A	NEW ISSUE	CP	10.11.23
REV.	DESCRIPTION	BY	DATE
DESIGN	90	DART AEROSPACE LTD	
DRAWN	90	HAWKESBURY, ONTARIO, CANADA	
CHECKED	90	DRAWING NO.	REV. A
MFG. APPR.	90	D206-667-147	SHEET 1 OF 4
APPROVED	90	TITLE	SCALE
DE APPR.	90	CROSSTUBE ASS'Y (206L MID FWD)	NTS
DATE	10.12.23	COPYRIGHT © 2010 BY DART AEROSPACE LTD THIS DOCUMENT IS PRIVATE AND CONFIDENTIAL AND IS SUPPLIED ON THE EXPRESS CONDITION THAT IT IS NOT TO BE USED FOR ANY PURPOSE OR COMMUNICATED TO ANY OTHER PERSON WITHOUT WRITTEN PERMISSION FROM DART AEROSPACE LTD.

DRAWING NO. D206-667-147	TITLE CROSSTUBE ASS'Y (206L MID FWD)	REV. A	<b>DART AEROSPACE LTD ENGINEERING ORDER</b>		D.E.O. NO. D206-667-147-A-1	SHEET NO. SHEET 1 OF 1	SCALE NTS
DRAWN <i>q</i>	CHECKED <i>ASS</i>	MFG. APPR. <i>JB</i>	APPROVED <i>MD</i>		DE APPR. <i>MD</i>		
DATE 11.07.15	DATE 11.07.20	DATE 11.07.21	DATE 11/07/21		DATE 11.07.21

DRAWING NO. D206-667-147	TITLE CROSSTUBE ASS'Y (206L MID FWD)	REV. A	DART AEROSPACE LTD ENGINEERING ORDER	D.E.O. NO. D206-667-147-A-2	SHEET NO. SHEET 1 OF 1	SCALE NTS
DRAWN AJS	CHECKED	MFG. APPR.	APPROVED	DE APPR.		
DATE 12.08.02	DATE 12.08.02	DATE 12.08.02	DATE 12.08.02	DATE 12.08.02	DATE 12.08.02

DETAIL P  
BONDING STRAP INSTALLATION 2 PL

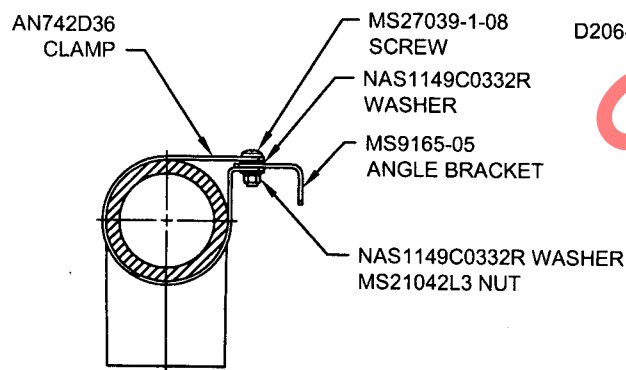
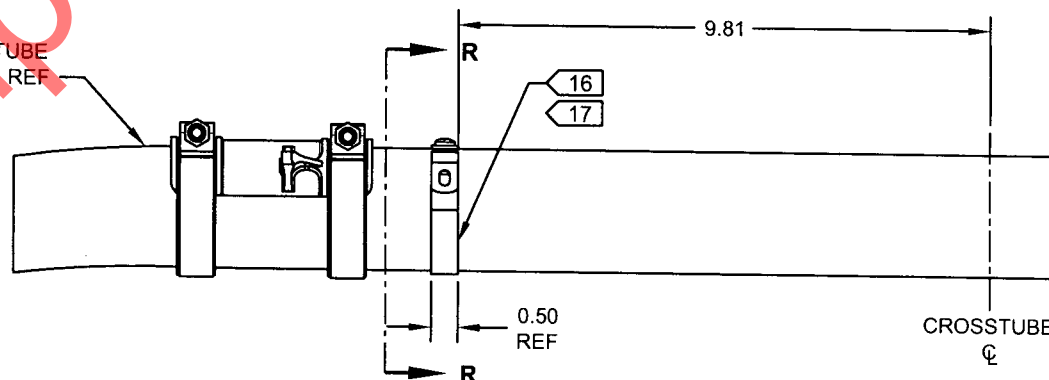
ADD ELECTRICAL GROUNDING STRAP

- 16) MASK AREA UNDER CLAMP PRIOR TO PAINTING
- 17) SEAL EDGES WHERE AN742D36 CLAMP MEETS WITH THE CROSSTUBE USING SIKAFLEX-241/-291 OR MIL-S-8802 CLASS B2 OR PROSEAL 890 SEALANT
- 18) PERFORM RESISTANCE CHECK TO ENSURE MAX RESISTANCE IS 10 MILLIOHMS
